| "DOCUMENT UNCONTROLLED IF PRINTED" |                                  |        |          |         |        |            |
|------------------------------------|----------------------------------|--------|----------|---------|--------|------------|
| <b>Recall<br/>16V769</b>           | Engine May Start Without Warning | 1 OF 3 |          | SER     | C.Ward | 10/24/2016 |

**The purpose of Recall 16V769 is on certain vehicles, the rear run safety switch (lockout) was not wired properly. This allows the vehicle to start with the possibility of a mechanic working on the engine. This could increase the risk of mechanic safety causing injury and/or death.**

**Correction:** Re-wire and add a relay to correct the circuit

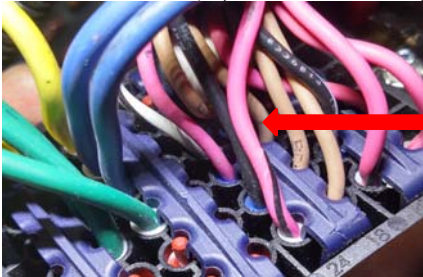
3. Locate the Black Wire (Bay 7 of PDM - next to white wire), cut, and connect to the Black wire in the Jumper Harness with butt connector (crimp and heat shrink)

4. Locate the Tan Wire (Bay 18 of PDM - 3rd wire up), cut, and connect to the Red wire in the Jumper Harness with butt connector (crimp and heat shrink)

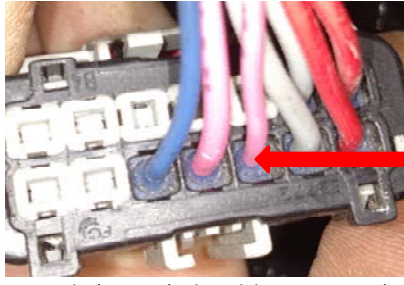
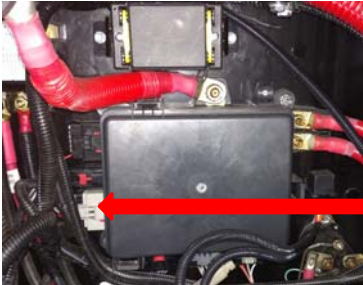
7. At the Grey Plug, locate smaller pink wire in the plug, follow the wire to a butt connection in the sheathing, and cut out the butt connector section (discard)

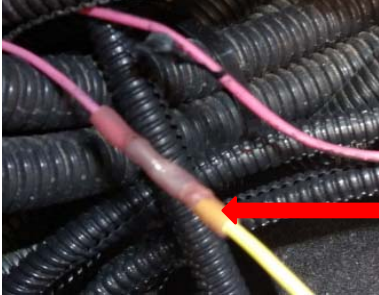
8. Connect the Yellow wire in the Jumper Harness to the Pink Wire on the 'Harness' side with butt connector (crimp and heat shrink)

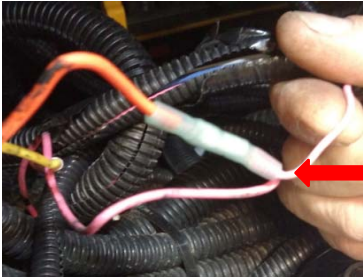
9. Connect the Orange wire in the Jumper Harness to the Pink Wire on the 'Plug' side with butt connector (crimp and heat shrink)
